**CITY OF KELOWNA**  
**MEMORANDUM**

**DATE:** May 5, 2008  
**TO:** City Manager  
**FROM:** Planning & Development Services Department  
**APPLICATION NO.** OCP07-0026, Z07-0077      **APPLICANTS:** Michael Gaspari  
DVP07-0216  
**AT:** 614-624 Francis Avenue      **OWNER:** Michael Gaspari

**PURPOSE:** TO AMEND THE OFFICIAL COMMUNITY PLAN DESIGNATION OF THE SUBJECT PROPERTY FROM SINGLE/TWO UNIT RESIDENTIAL TO MULTIPLE UNIT RESIDENTIAL - LOW DENSITY

# British Columbia Land Surveyors BUILDING LOCATION CERTIFICATE

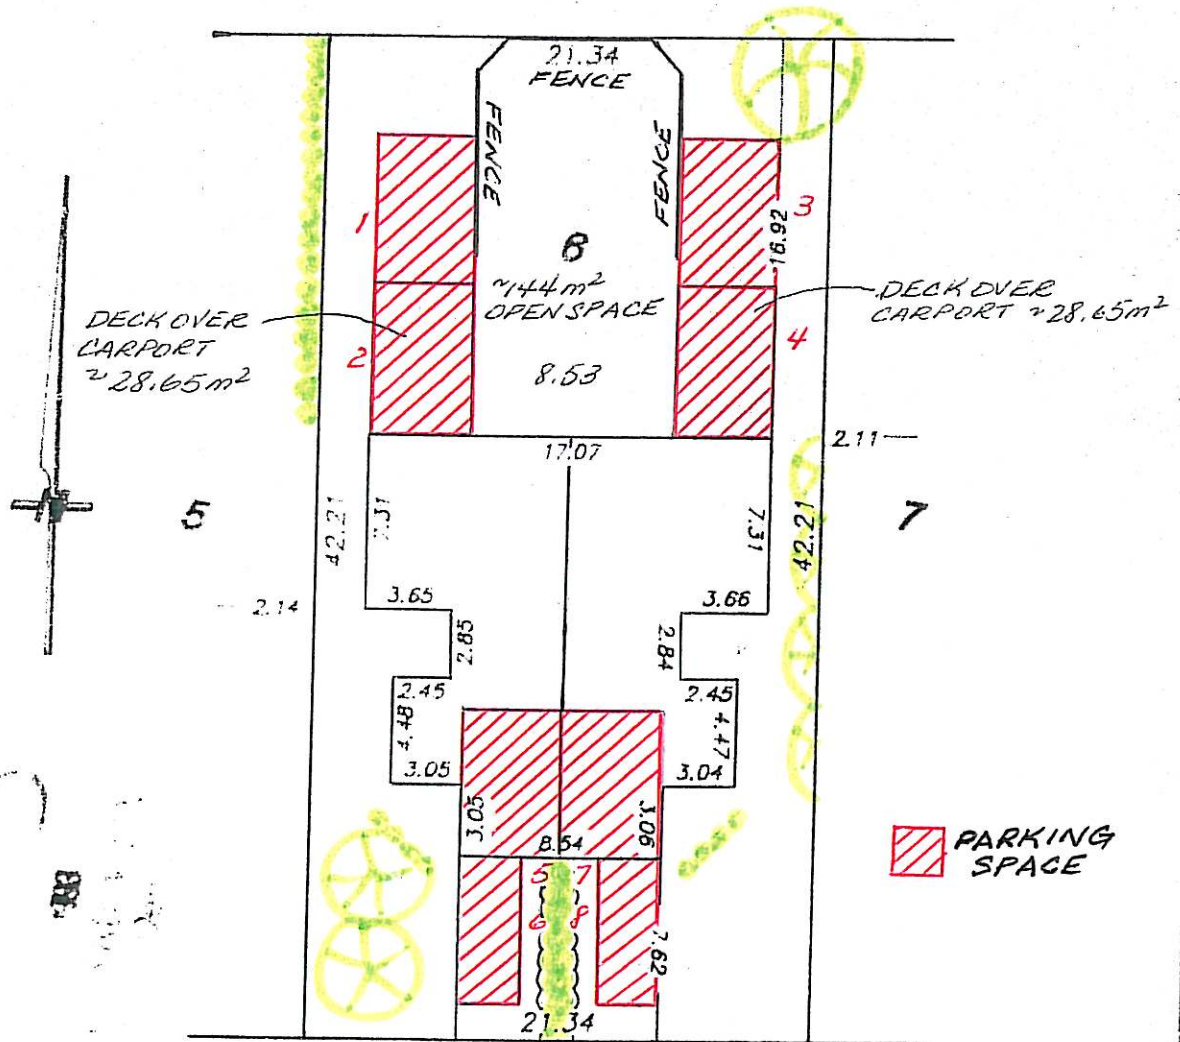
The calculation of total site coverage is based only on the paved parking/driveways as show on the attached site plan. Any and all other parking provided on the property must be eliminated to achieve the maximum site coverage of 50%. In particular, the unpaved parking spaces in front yard must be removed and the area landscaped with the appropriate landscape buffer as per Zoning Bylaw Section 7.6 (3.0 m wide vegetative buffer).
